Rezoning Transportation Analysis

Petition Number: 2020-012

Date	Description
02-18-2020	First Review
04-16-2020	Second Review
05-20-2020	Third Review

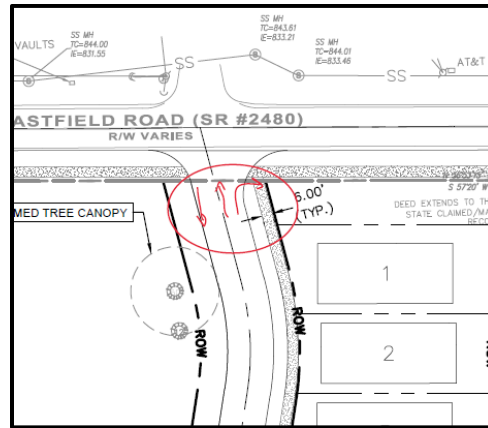
- ~~5. The petitioner should revise the site plan and conditional note(s) to construct a left turn lane on Eastfield Road into Road "A".~~
- ~~6. The petitioner should revise the site plan and conditional note(s) to construct a left turn lane on Browne Road into Road "B".~~
- ~~7. CDOT is requesting the petitioner revise the site plan and conditional note(s) to create a three-lane section on Road "A" where it connects to Eastfield Road as shown below.~~
